**Source:** Leece-Neville Heavy Duty Systems Division  
**Bulletin No:** TSB-1212 **Date:** August 19, 2022  
**Models:** 4800 ign. excite  
**Subject:** Terminal Id. from 4800 to HAB alternators

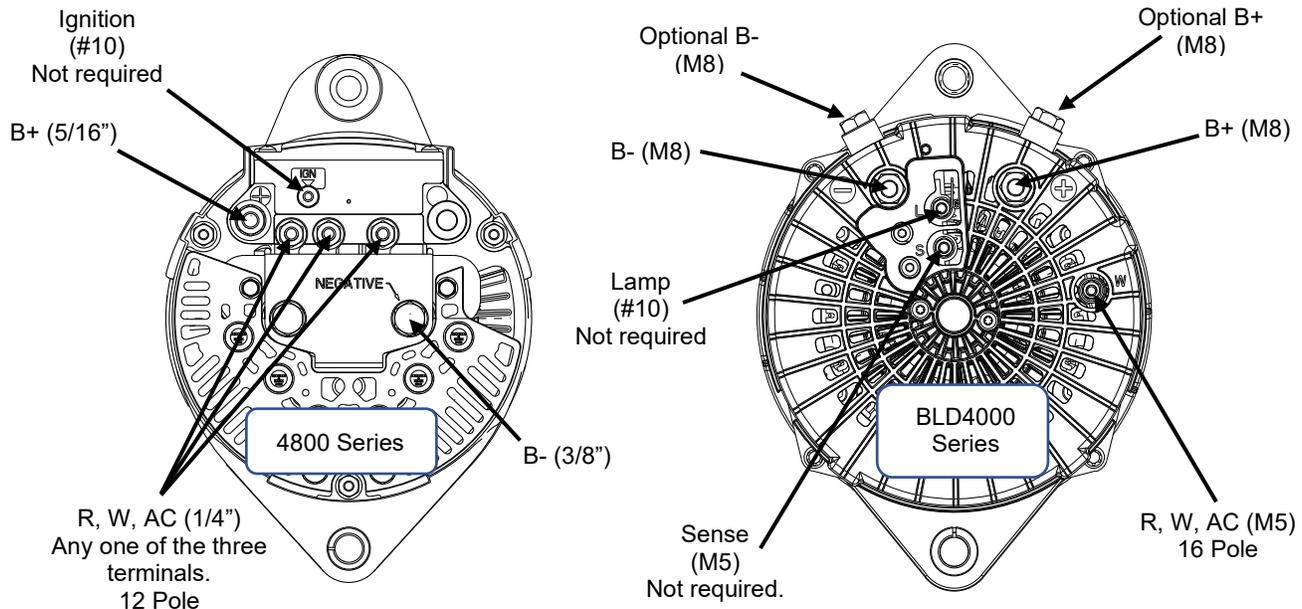
Various 4800 series ignition excite brush alternators can be replaced by BLD4000 series brushless alternators. See matrix below.

This document will help identify terminal location variances.

Note: Wire termination and routing will require changes.

Ignition lead used on existing 4800 series alternators are not required. Insulate this wire to prevent shorting and secure out of the way.

4800 series alternators listed on this document are grounded earth return where the BLD4000 series replacements are insulated return. Depending on the vehicle wiring a ground strap maybe required.
